Summary of Items Discussed in APSEC Discussion Forum on 18 May 2012

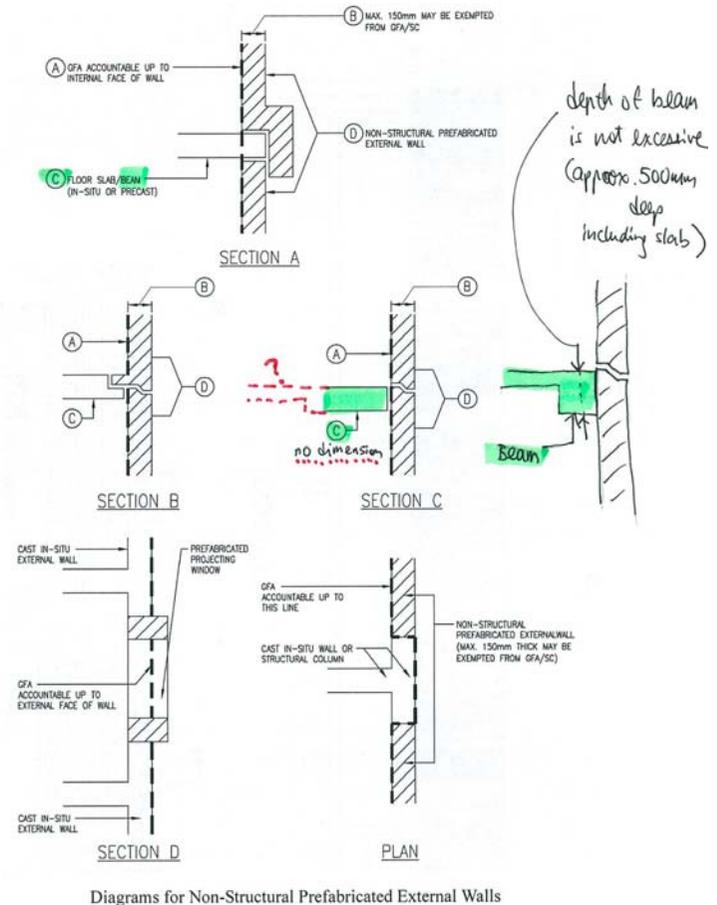
<p>open kitchens are normally designed as part of the living cum dining room of a residential unit we propose that the only requirement should be for the living cum dining room window to satisfy B(P)R 30 & 32 as a room for habitation generally and with the ventilation area slightly increased to cater for the requirement under B(P)R36 for a notional area of the open kitchen. No other requirement should be imposed if the layout of the same living cum dining room should have been acceptable under the regulations without the open kitchen. Can BD confirm this?</p>	<p>lighting and ventilation. In calculating the openable window area provision for a living/ habitable room incorporated with open kitchen, the requirements stipulated in B(P)R 30(2)(a)(ii) might be adopted instead of B(P)R 36(2)(b).</p>
<p>3.</p>	<p><u>Criteria for architectural features</u> In previous forum BD has confirmed that there has been no change to the acceptance criteria for architectural features on external walls to screen off pipe works, which has been taken to mean that provided they are reasonable and not dominating the façade of the building architectural features/screens projecting from the external wall by not more than 500mm should be generally acceptable, including these screens for pipe works. It is noted that for such architectural features to be effective in screening off unsightly pipe works, they have to be reasonably non-transparent. However, some APs have experience that additional requirements have been imposed for the screens to be very transparent in order to be approved. This is quite contrary to the intention of providing such features/screens. Will BD please confirm that provided that these</p>	<p>HKIA supplemented that the features/screens were usually grilles or louvres and hence the proposed 30/70 ratio. However, BD's initial view was that 30% free area might be too low and requested HKIA to provide details with a higher free/solid ratio for consideration.</p>

<p>features/screens do not in effect result in a complete enclosure of the pipe works they should be acceptable? Alternatively a reasonable free area-solid area ratio (say 30%/70%) <u>per floor</u> for these screens may be agreed.</p>

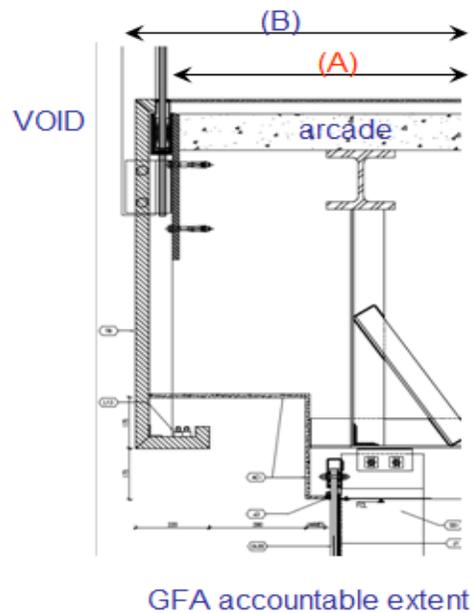
<p>Most suppliers claim that they have not developed such a model. Does BD have an approved list of suppliers for these Fire Shutters?</p>	
<p>17.</p>	<p><u>GFA accountable extent for atrium void</u> For measurement of GFA at edge of an atrium void, a reasonable way for measurement is towards the edge of concrete or steel structure. [Dimension (A) as marked on sketch attached below refers] However, in some cases, case officer considers GFA is also accountable for the small portion between the concrete structure and the interior cladding at the spandrel. [Dimension (B) as marked on sketch attached below refers]. This seems insensible as the cladding is an interior finish and is not accessible by visitors. Is there any clear guideline?</p>	<p>BD confirmed that for calculation of GFA of a floor involving atrium void, the parent structural support to cladding or other finishing materials should be included as accountable floor area.</p>
